Redline Revision
Dated April 25, 2011

SHA Approval Date
T.S. # 3218E1 T.I.M.S. # J676

**US 1 (BALTIMORE AVE) AND
MELBOURNE PLACE / LAKELAND DRIVE**
COLLEGE PARK, MARYLAND

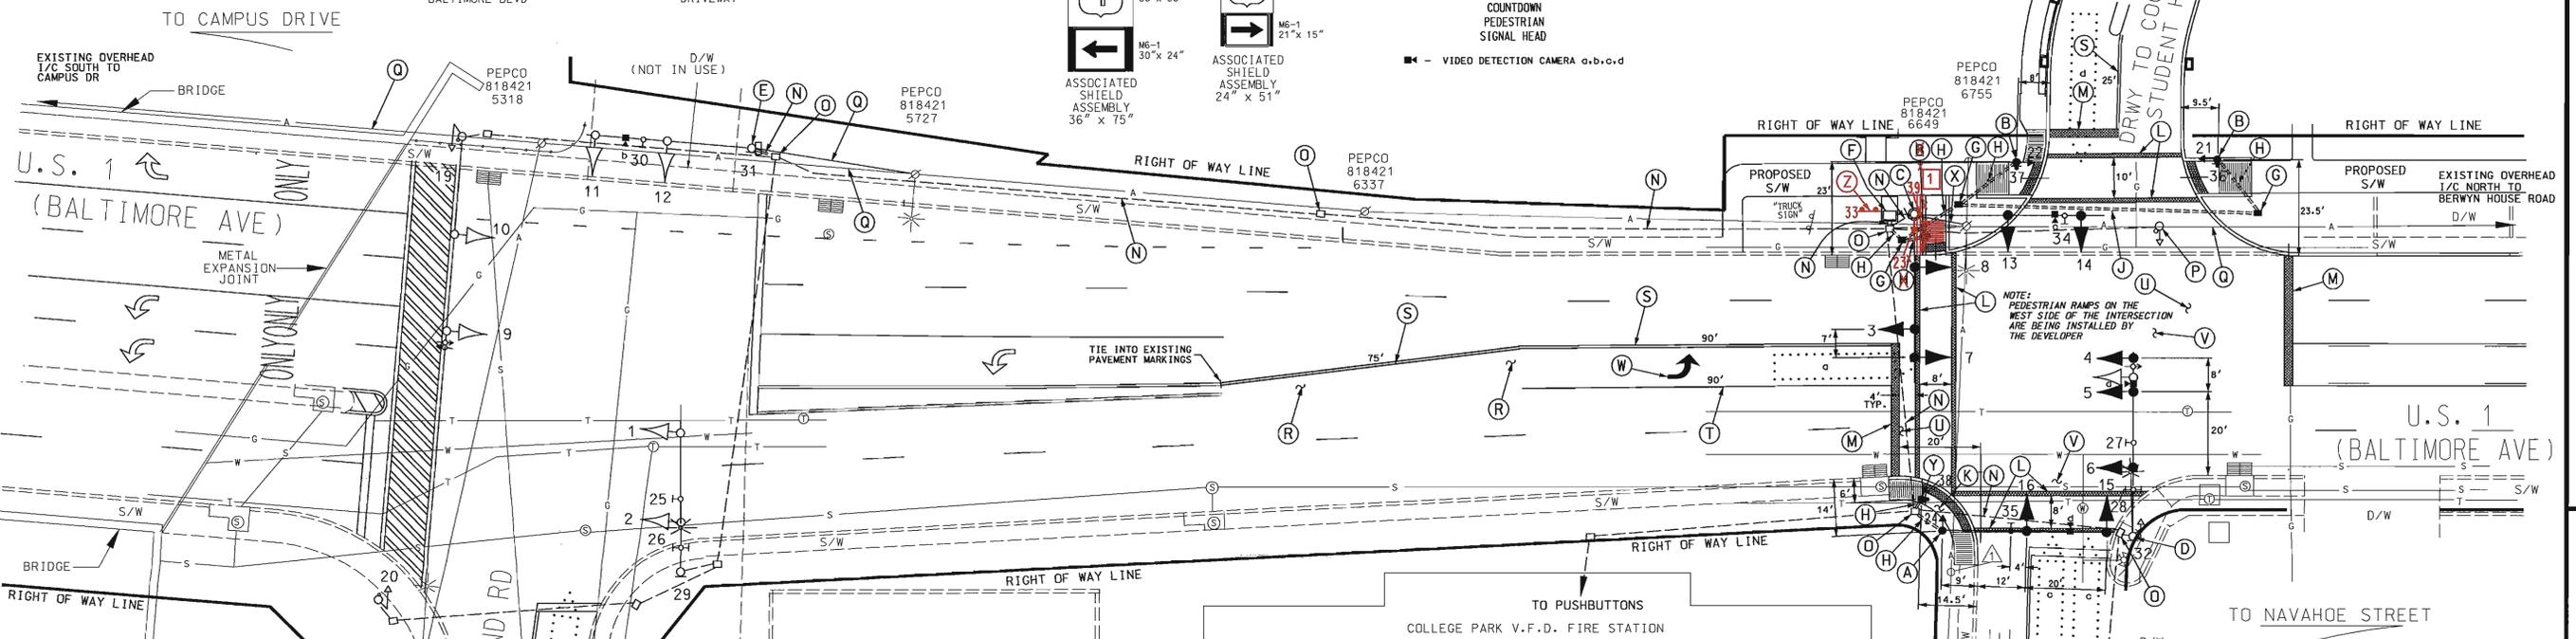
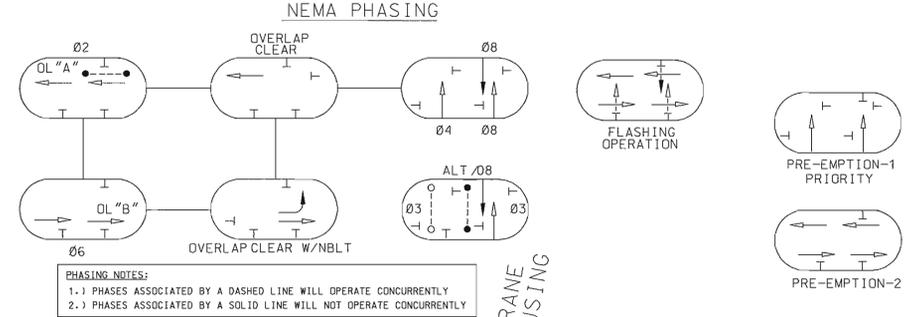
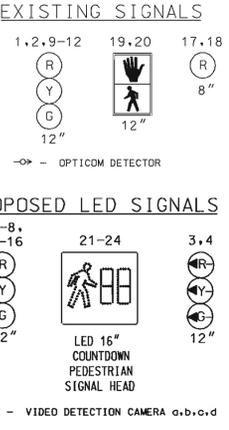
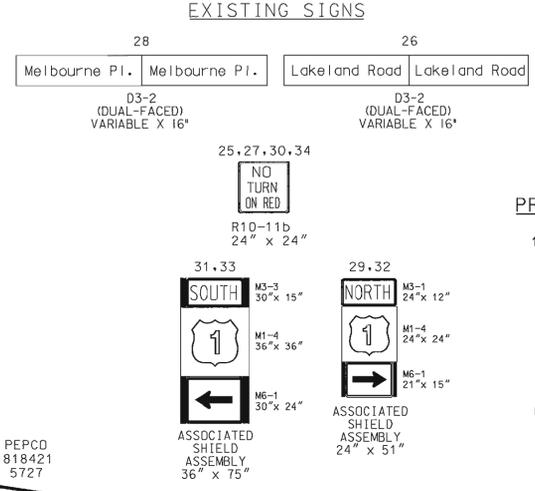
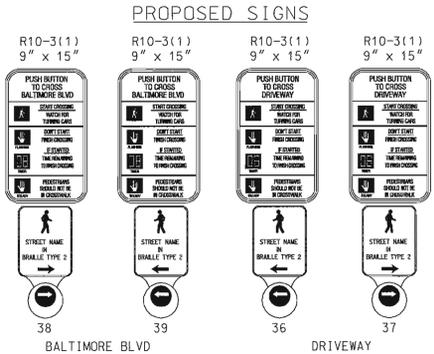
DRILL HOLES

DRILL HOLES

DRILL HOLES
